CURTISS-WRIGHT CORPORATION  
RESEARCH DIVISION  
QUEHANNA, PENNSYLVANIA  
U. S. A.

Subject: Application to Amend Present Class 104 Reactor  
Operation License to 1.7 and 4 Mw Power Level

APPENDIX VII  
Amendment to CWR 4062

Answers to Questions of AEC Licensing Branch  
Divisions of Licensing and Regulations

Figure 1. Dose Rate at Pool Surface vs. Operating Time at One Megawatt

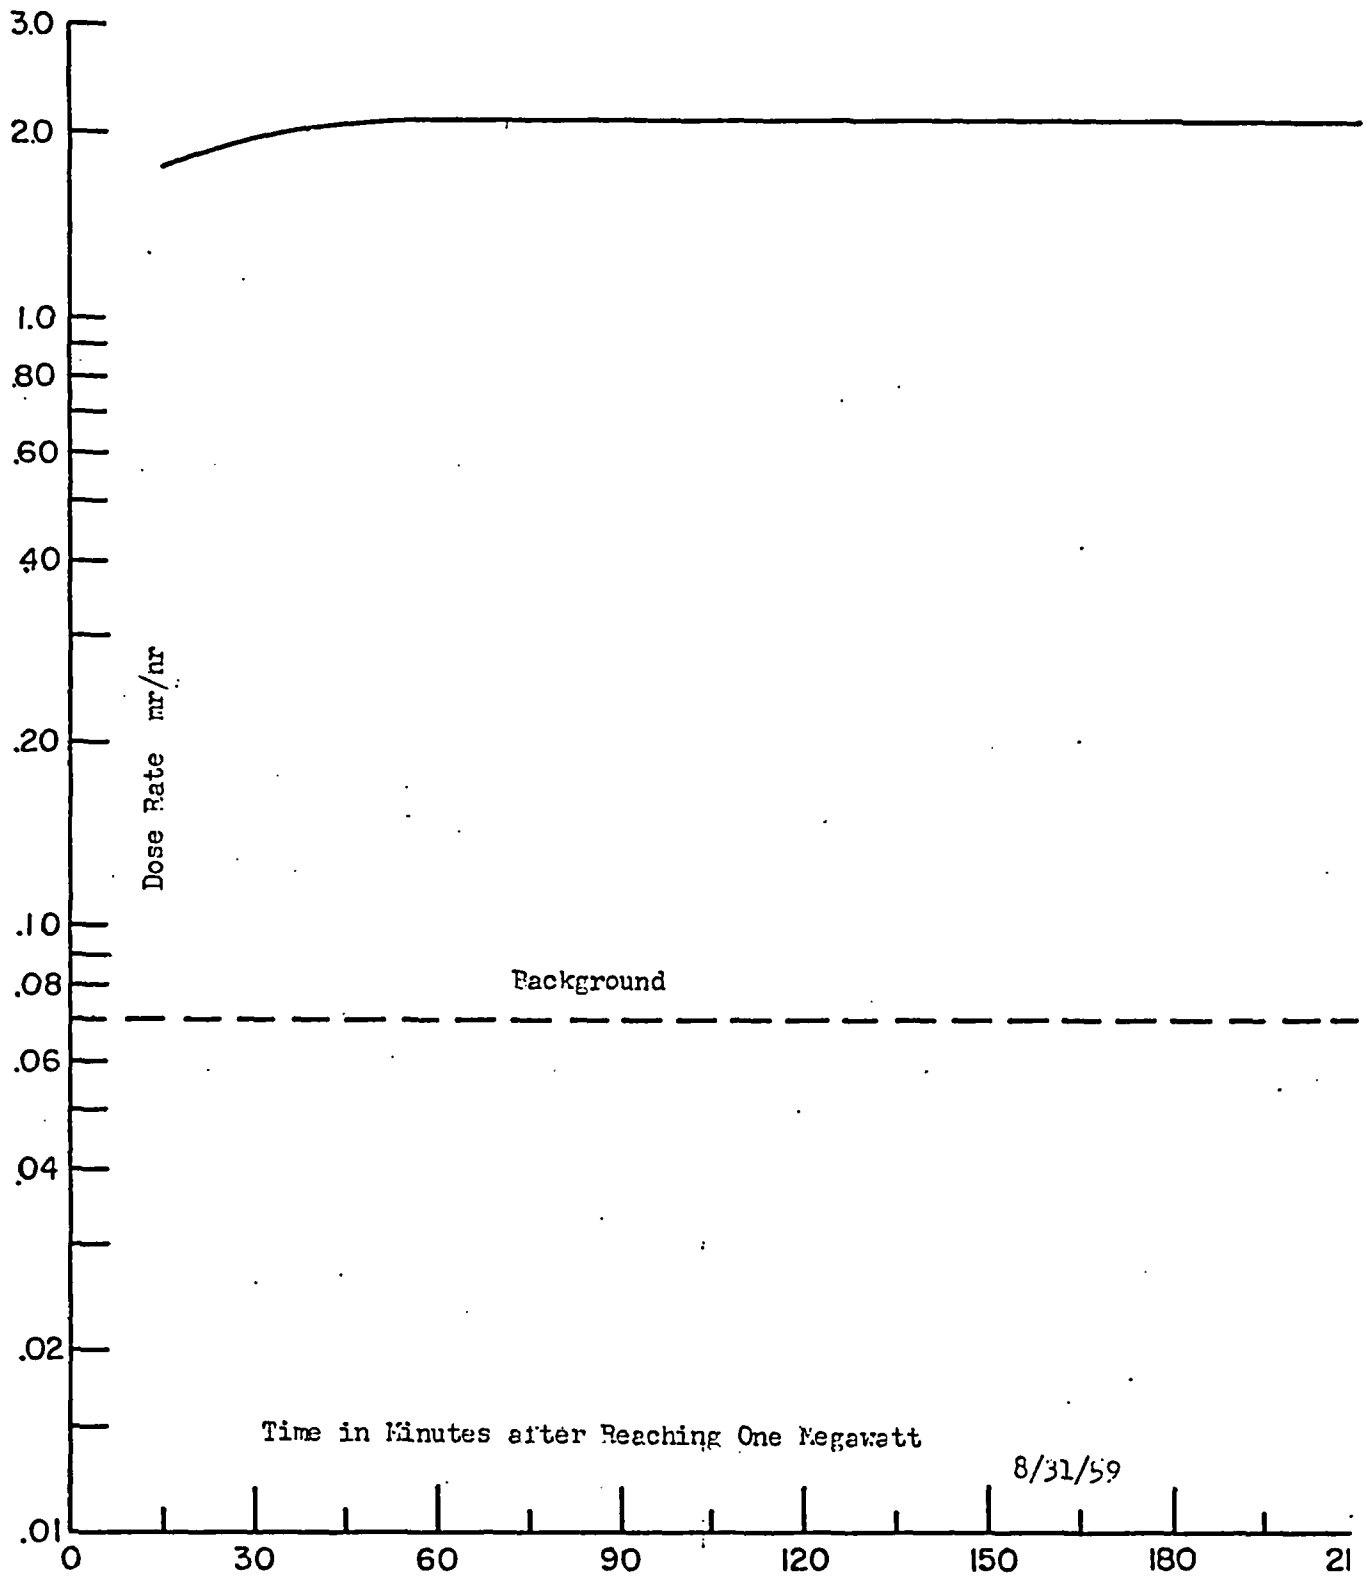
2. The activation of the pool water due to oxygen-16 activation is described in the report. It is also of interest to know the activation of the pool water due to longer life of the activated oxygen-17. What is the increase in dose-rate at the surface of the water during an operating cycle?

The pool water activation by the formation of  $C^{14}$  from the reaction  $O^{17} (n, \alpha) C^{14}$  has been computed assuming a 60% neutron absorption in water. This leads to a formation rate of  $4.86 \times 10^{-3}$   $\mu\text{c}/\text{sec}$  or approximately 2.5 millicuries in a 144-hour operation period. Because of the type of emission (0.155 Mev  $\beta^-$ ), there will be no visible increase in dose rate at the water surface from this emitter.

The increase in dose rate at the surface of the water during an operating cycle with steady state operation at 1 Mw is shown in Figure 1. The equilibrium dose rate is 2.1 mr/hr for continuous operation at 1 Mw of power.

The dose rate at 4 Mw will be somewhat more than 4 times this value; however, it is expected to be in the range of 10 to 15 mr/hr. Only actual operation will give the actual dose rate at 4 Mw.

FIGURE 2

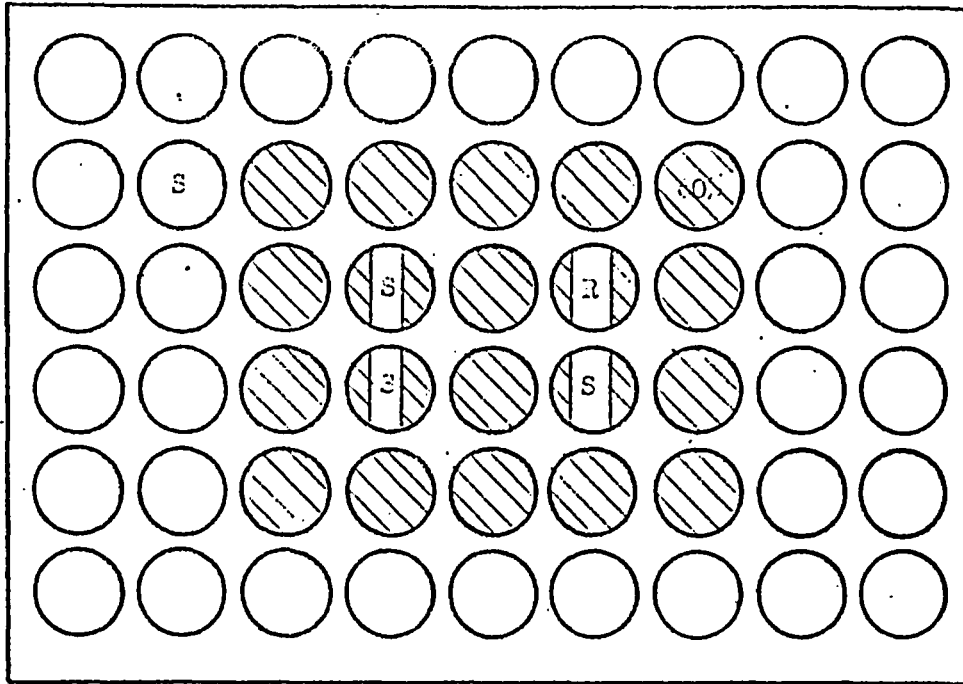
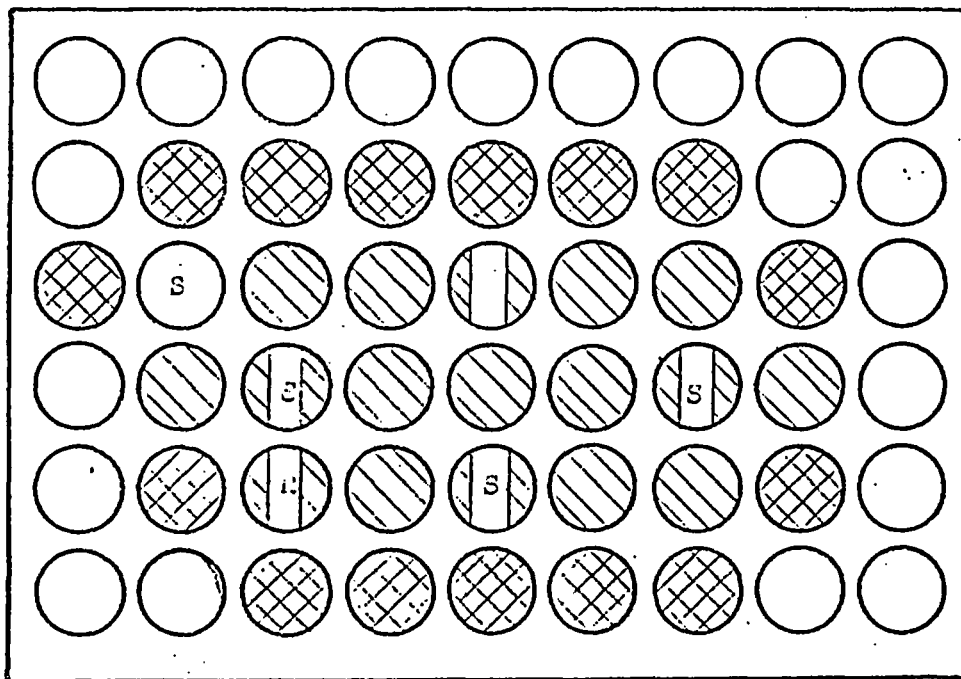
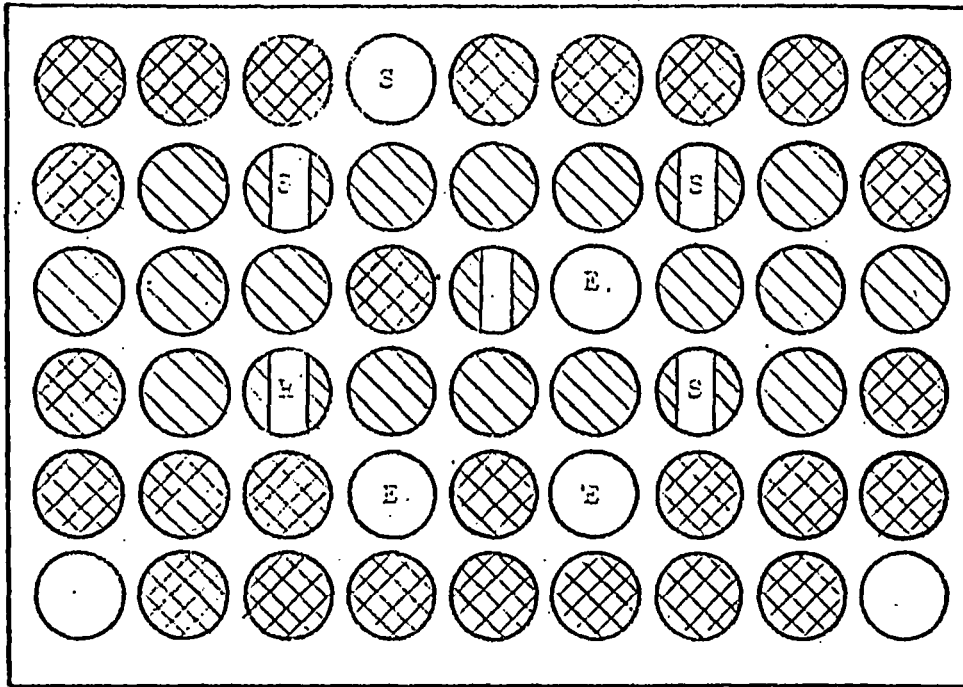
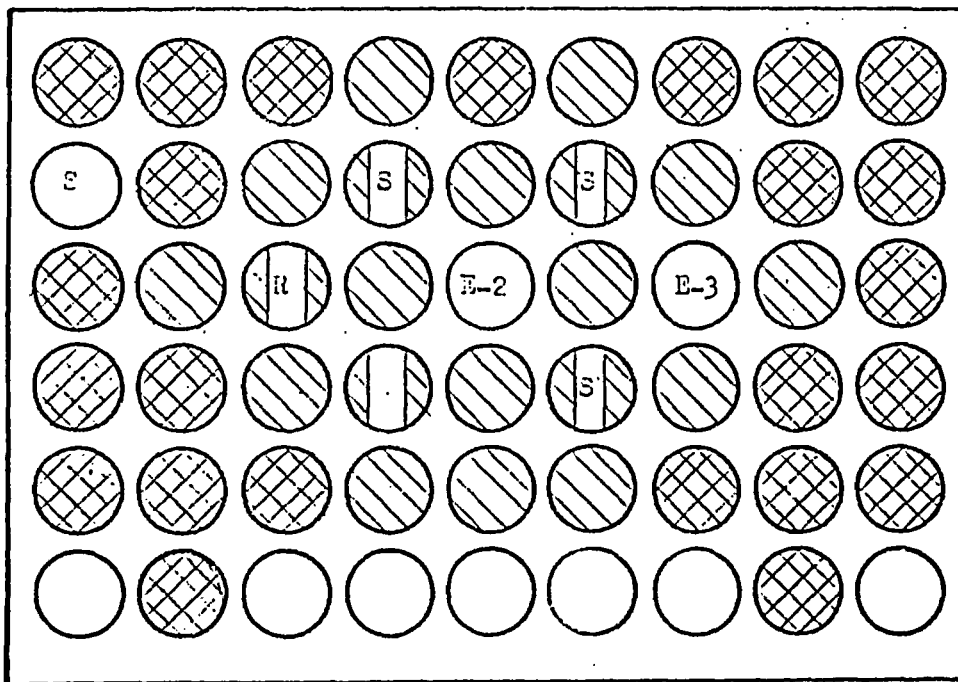
3. What is the core configuration to be used with each type of reflector? Discuss the excess reactivity available for each core geometry and the reactivity control available in the control rods for each case.

The Curtiss-Wright Research Reactor design affords a high degree of flexibility in core configuration; hence, figures depicting typical graphite-reflected cores are attached (Figures 2, 3, 4, and 5). Figure 2 represents a water-reflected core; whereas, the other figures are representative of graphite-reflected cores.

The following tabulates the total excess reactivity present in each of the representative loadings, and the reactivity control obtainable for each loading.

<u>Loading #</u>	<u>Total Excess Reactivity % <math>\Delta</math> k/k</u>	<u>Total Rod Worth % <math>\Delta</math> k/k</u>
5	1.67	8.34
24 D	0.87	6.69
27 H	1.36	4.89
29	2.81	7.76

Future loadings utilizing beryllium oxide reflectors generally will be similar to the graphite-reflected loadings shown on the enclosed figures. Four safety rods will be available for control of cores reflected with beryllium oxide rather than the three presently on hand.

REACTOR POOL COOLING, CLEANING AND PURIFICATION SYSTEM

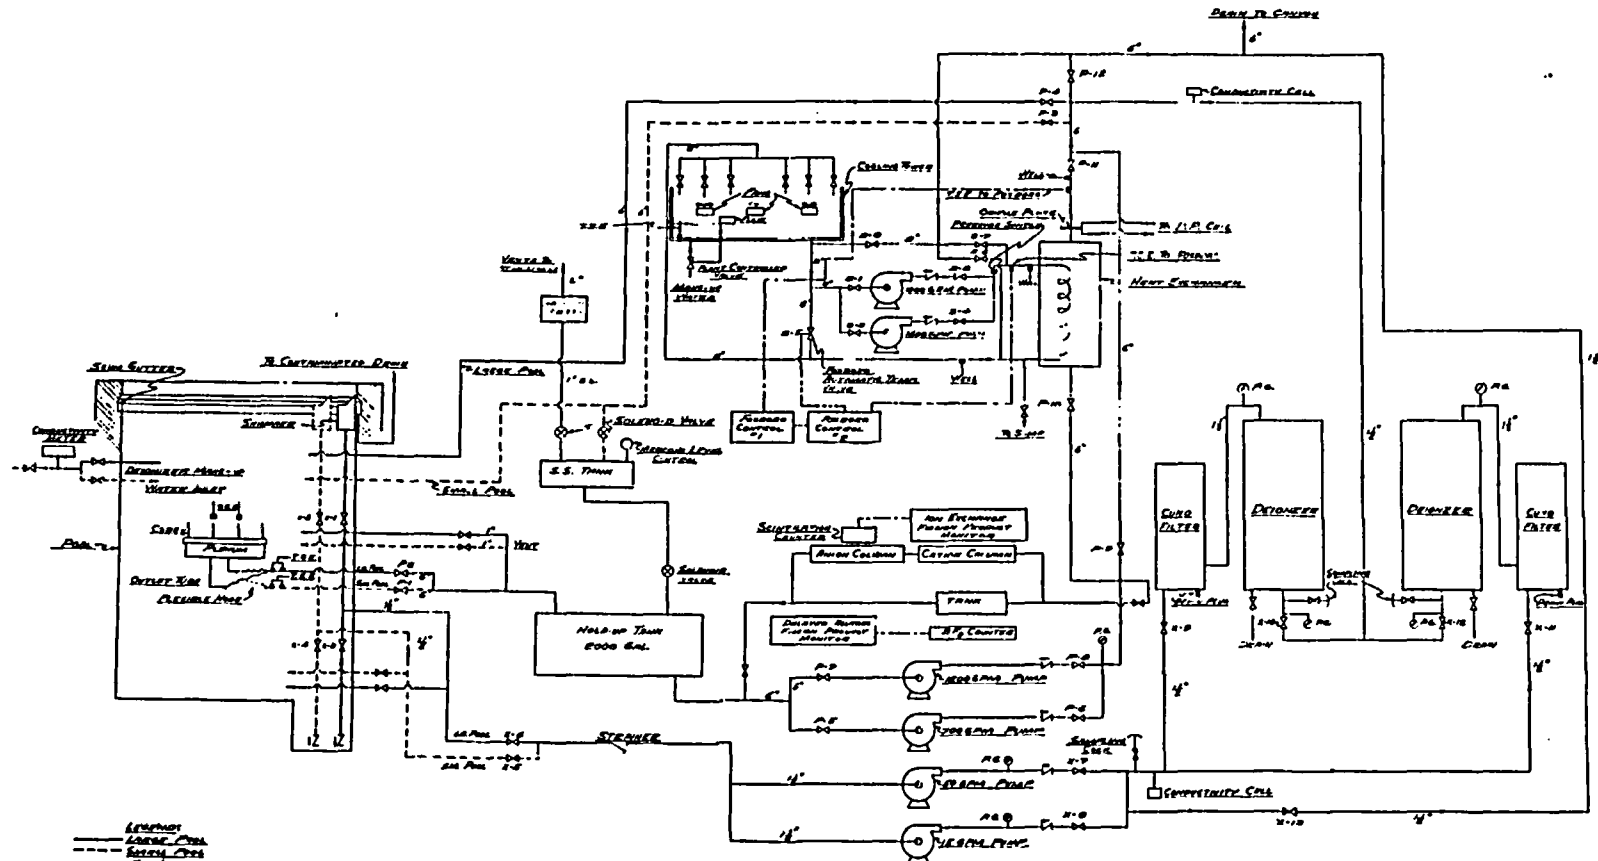
2. Describe the procedure in changing from convection cooling to forced circulation. Are there any interlocks involved in this operation?

Convection cooling can be used for power levels up to and including 100 kw and, if desired, forced cooling also may be used in the 0 - 100 kw range. For power levels greater than 100 kw, forced cooling is required. Assuming the reactor is operating on convection cooling, and it is desired to use forced cooling, the following steps in chronological order are taken.

- 1) Announce over PA system that reactor is being shut down.
- 2) If on "auto" control, switch to manual and insert all rods at their normal drive rates shutting down the reactor.
- 3) Prepare cooling system for forced circulation as described under Cooling System, Question 1, above and as detailed in SOP 301.
